CURRENT PLANNING APPLICATION: 11/0104/FL

For: CHANGES TO BOUNDARY TREATMENTS

**At: EXISTING RETAIL UNIT (formally known as) McNEIL'S COUNTRY
STORE, SNEATON LANE, RUSWARP, WHITBY, YO22 5HL.**

PROPOSED ALTERATIONS TO EXISTING BOUNDARY TREATMENTS
 At: McNEIL'S COUNTRY STORE, SNEATON LANE, RUSWARP, WHITBY, YO22 5HL
 For: B.A.T.A. Ltd.
 DRAWING 11A EXISTING & PROPOSED SITE PLANS SCALE: 1:500 @ A3
 Rev A: Highway visibility splays added March 2011
 David Ward Architectural Ltd. 01653 658 229 Feb 2011

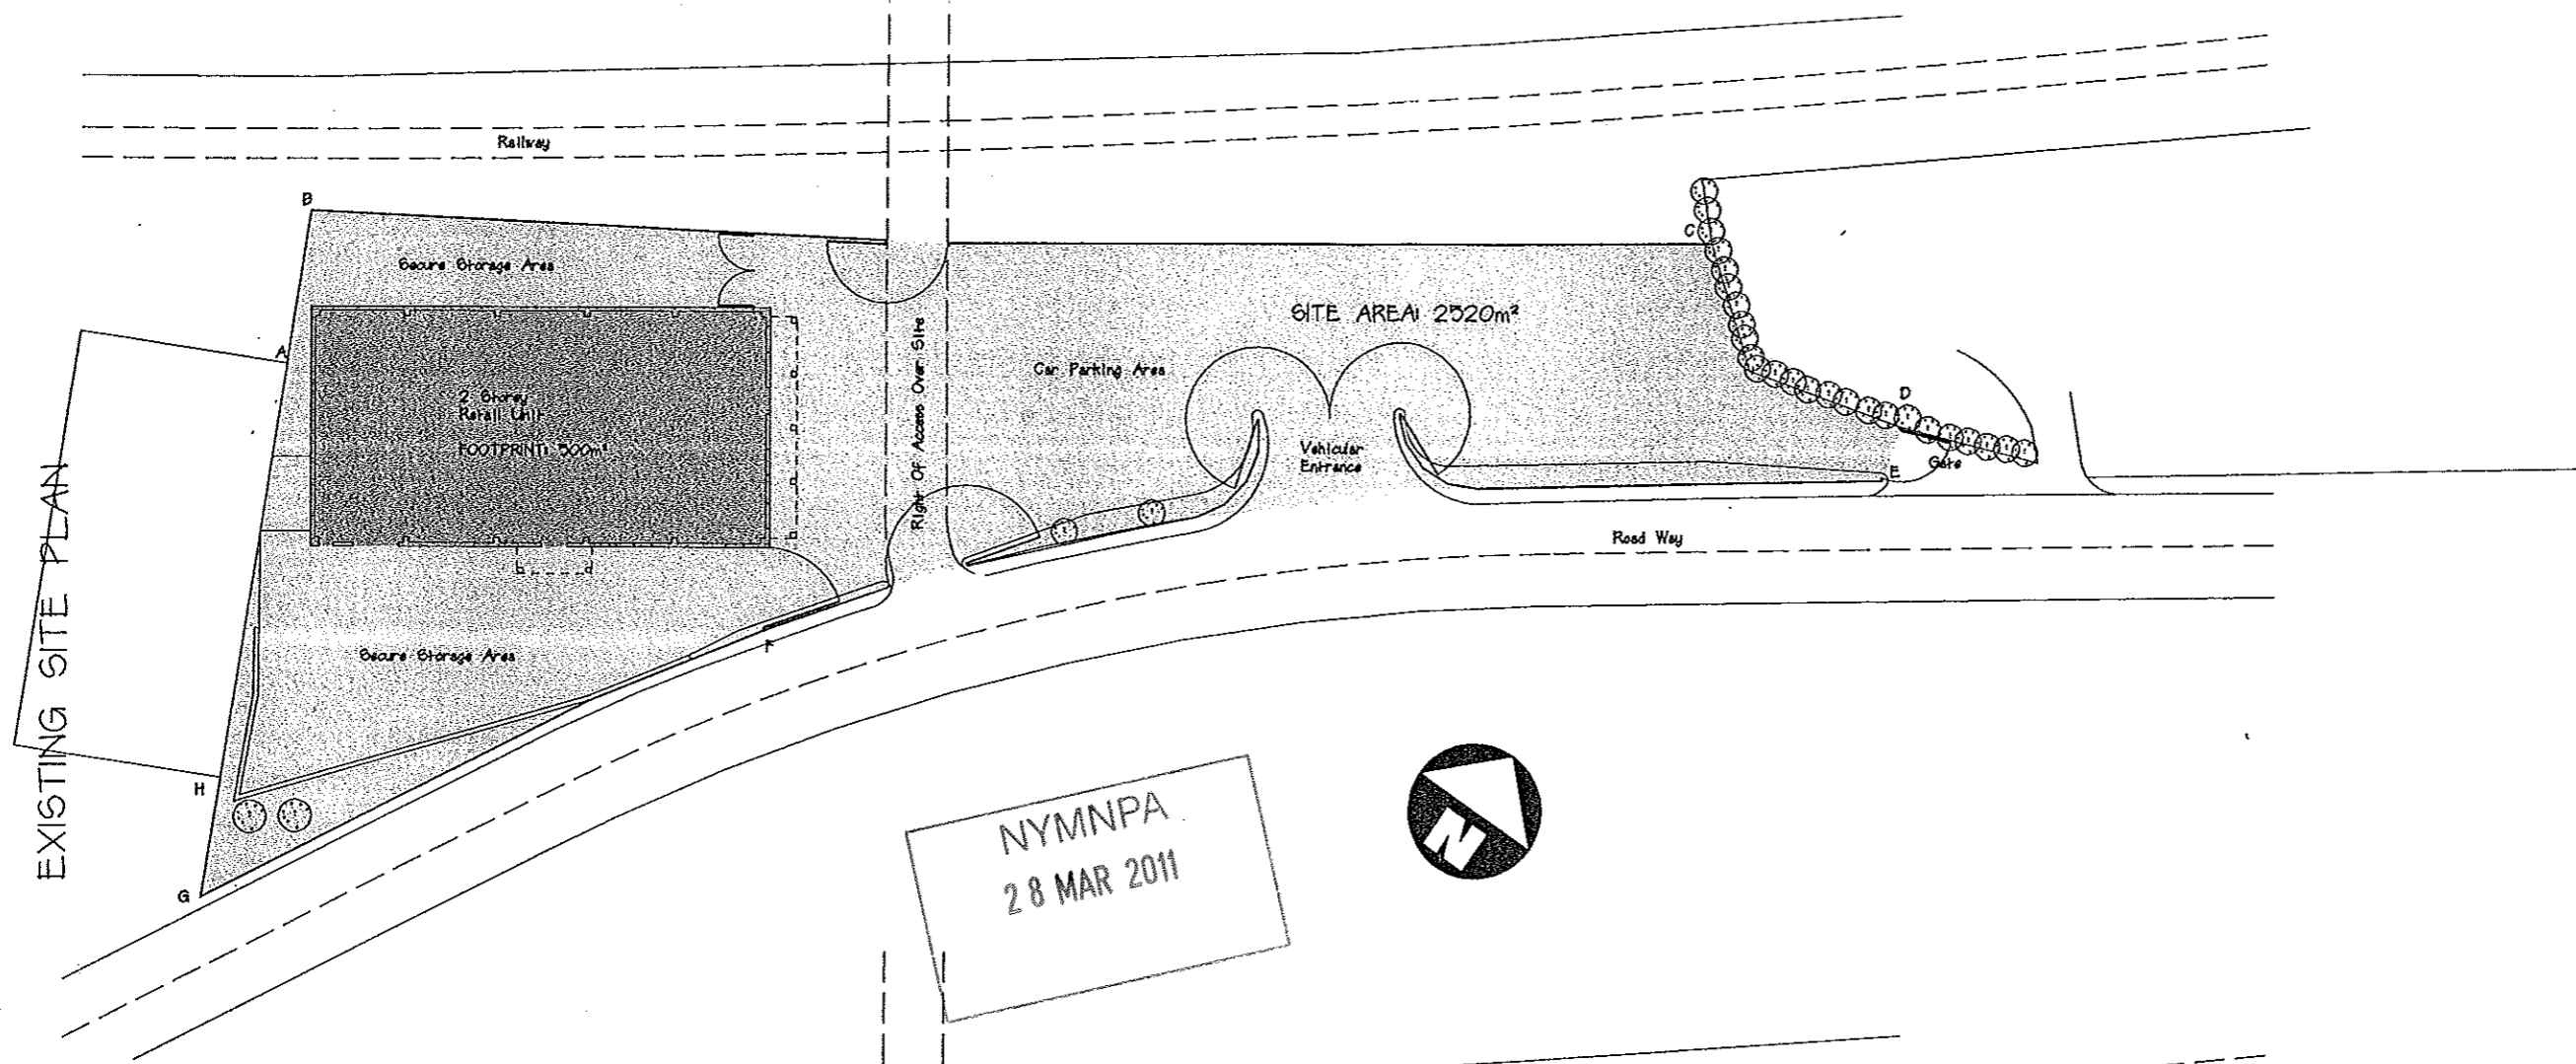
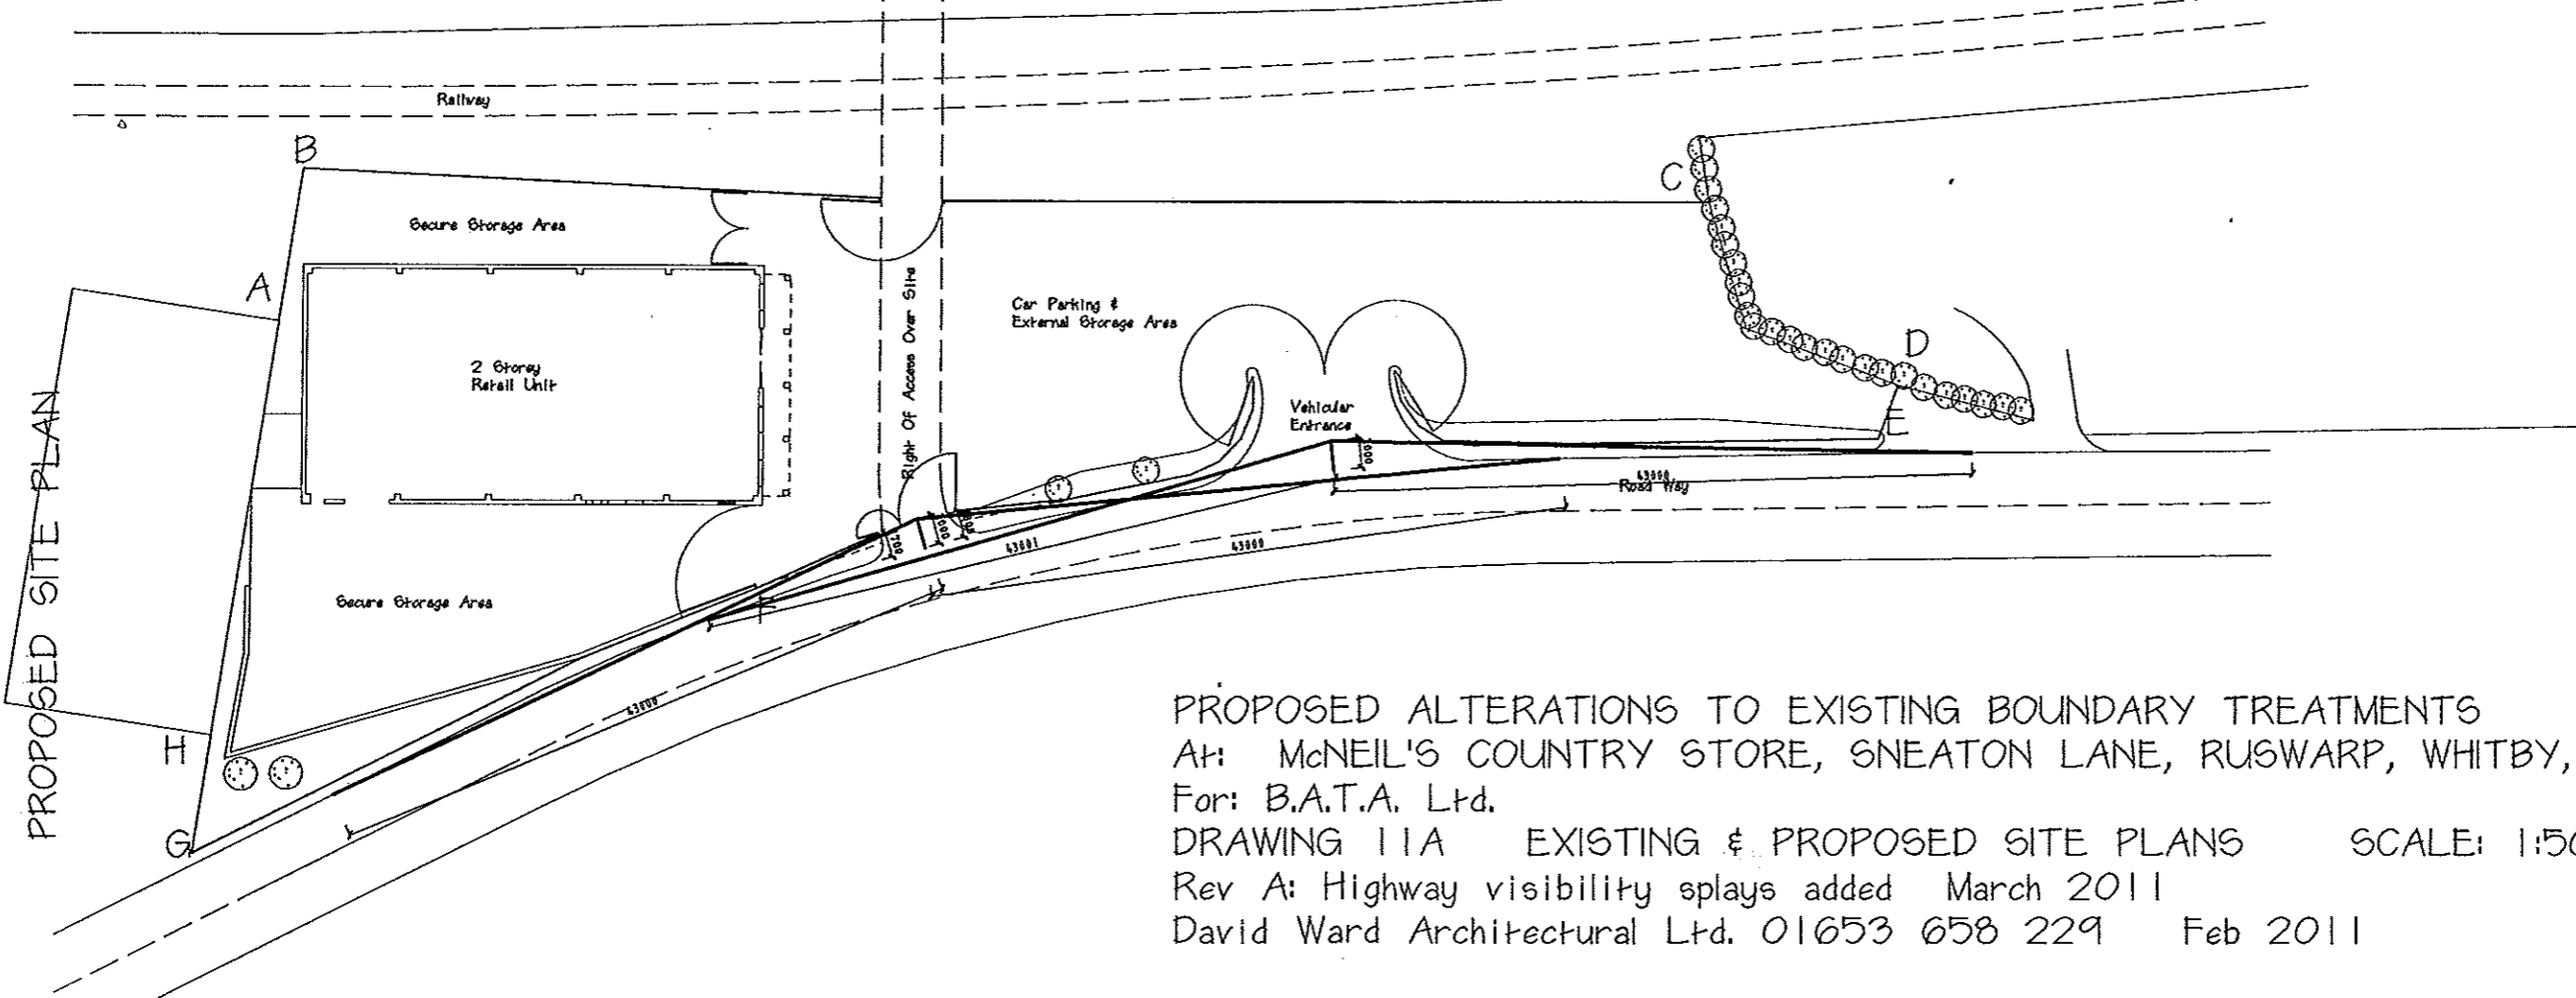
There are three small areas where the line of the existing fence would be in conflict with the site lines and I have therefore amended the drawings to show the implications to the fence line. In my view these are very minor and do not have any bearing on the overall appearance of the boundary treatment facing the road. The applicant will ensure that the visibility splays will satisfy Highway requirements if you are mindful to approve the application and the changes are shown on the revised drawings 11A & 13C which are enclosed.

There are three small areas where the line of the existing fence would be in conflict with the site lines and I have therefore amended the drawings to show the implications to the fence line. In my view these are very minor and do not have any bearing on the overall appearance of the boundary treatment facing the road. The applicant will ensure that the visibility splays will satisfy Highway requirements if you are mindful to approve the application and the changes are shown on the revised drawings 11A & 13C which are enclosed.

NOTES
 Visibility splays 2m x 43m shown on drawings
 Areas where existing fence line obstructs
 visibility splays shown shaded
 New line of fence shown.
